DART AEROSPACE LTD		Work Order:	119624
Description: Bar		Part Number:	D3196-1
Inspection Dwg: D3196 Rev: C		Page 1 of 1

D3196-1 BAR

DRAWING NO. D3196	TITLE BAR	REV. C	DART AEROSPACE LTD ENGINEERING ORDER		D.E.O. NO. D3196-C-1	SHEET NO. SHEET 1 OF 2	SCALE NTS
DRAWN <i>ASS</i>	CHECKED <i>[Signature]</i>	MFG. APPR. <i>[Signature]</i>	APPROVED <i>[Signature]</i>		DE APPR. <i>[Signature]</i>		
DATE 08.08.27	DATE 08.08.28	DATE 08.08.29	DATE 08.08.29	DATE 08.08.29	DATE 08.09.04

D3196-1 BAR

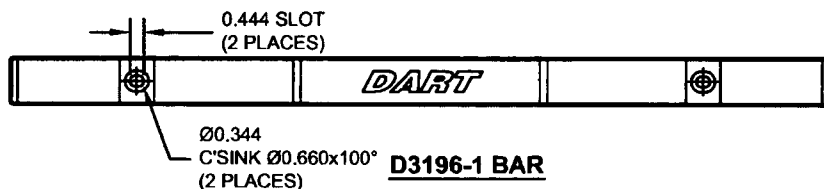
SHEET 1 MODIFY SLOT DIMENSIONING ON D3196-1 AS SHOWN:

D3196-3 BAR

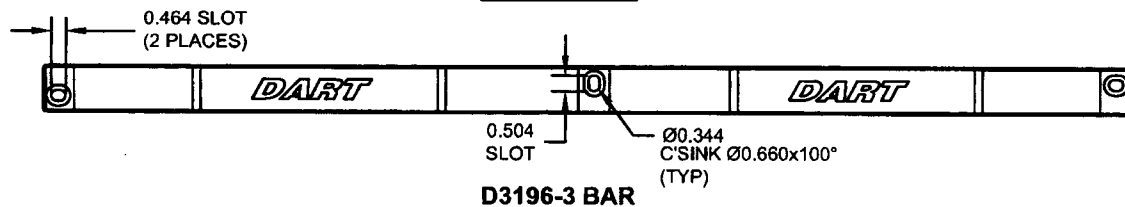
SHEET 2 MODIFY SLOT DIMENSIONING ON D3196-3 AS SHOWN:

D3196-4 BAR

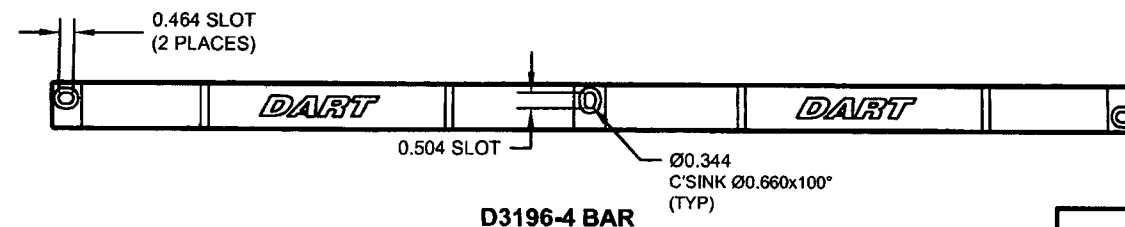
SHEET 3 MODIFY SLOT DIMENSIONING ON D3196-4 AS SHOWN:

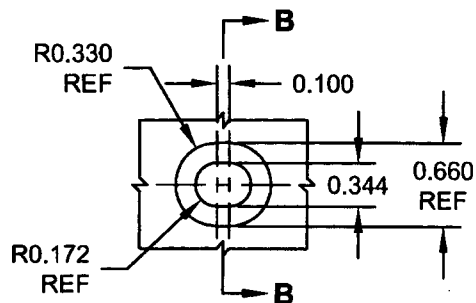
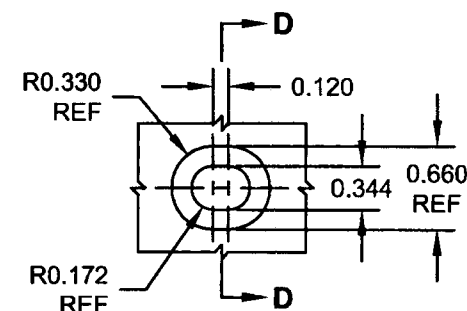
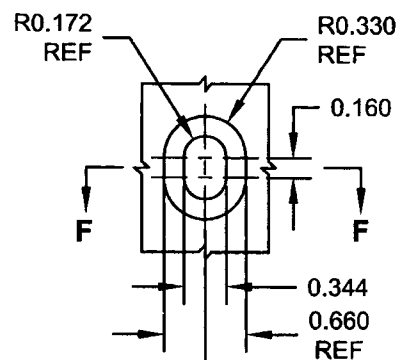
NOTE: THIS CHANGE HAS BEEN DONE TO CLARIFY SLOT DIMENSIONS ONLY. NO CHANGES HAVE BEEN MADE TO THE PARTS
SEE NCR 08-051 FOR FURTHER INFORMATION
ALL OTHER INFORMATION REMAINS UNCHANGED
